Access Compliance Report Public Rights-of-Way (Curb Ramps)

Intersection ID: 16724 Main Street: CHARLOTTE_PARK_DR Cross Street: PRESSLEY_RD Location: SW

ADA ID: 2536D0A8DC7C Ramp Type: PerpDiag Initial Pass/Fail: Fail Overall Compliance: No Severity Score: 13.75

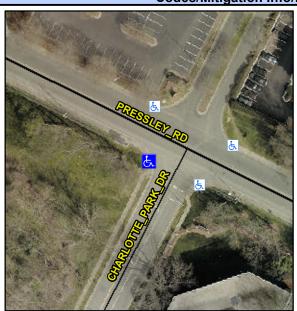
Not Found, R304.2.2, R304.5.3

Field Measurements/Component Compnance						
	Compliance Description		Data	Compliance Description		Data
	N/A	Ramp Length (in)	48.0	No	Ramp Slope (%)	9.0
	Yes	Ramp Width (in)	48.0	No	Ramp XSlope (%)	2.4
	N/A	Flare Type LT	N/A	N/A	Flare Type RT	N/A
	N/A	Flare Slope LT (%)	N/A	N/A	Flare Slope RT (%)	N/A
	N/A	Flare Traversable LT?	N/A	N/A	Flare Traversable RT?	N/A
	N/A	Landing Length (in)	N/A	N/A	DWS Provided?	N/A
	N/A	Landing Width (in)	N/A	N/A	DWS Contrast?	N/A
	N/A	Landing Slope (%)	N/A	N/A	DWS Length (in)	N/A
	N/A	Landing X Slope (%)	N/A	N/A	DWS Full Width?	N/A
	N/A	Landing Curb? (Y/N)	N/A	N/A	DWS Offset (in)	N/A
	N/A	Shared Landing?	N/A			
	N/A	Gutter Ponding?	N/A	N/A	Gutter Slope (%)	N/A
	N/A	Gutter Lip Ht (in)	N/A	N/A	Gutter X Slope (%)	N/A
	N/A	Painted X Walk1?	No	N/A	Painted X Walk2?	No
		X Walk 1 Direction	To SE		X Walk 2 Direction	To NE
	N/A	X Walk 1 Width (in)	N/A	N/A	X Walk 2 Width (in)	N/A
		X Walk 1 Slope (%)	2.4		X Walk 2 Slope (%)	3.6

Remove & Replace Curb Ramp With Two New Directional Ramps or Equivalent.
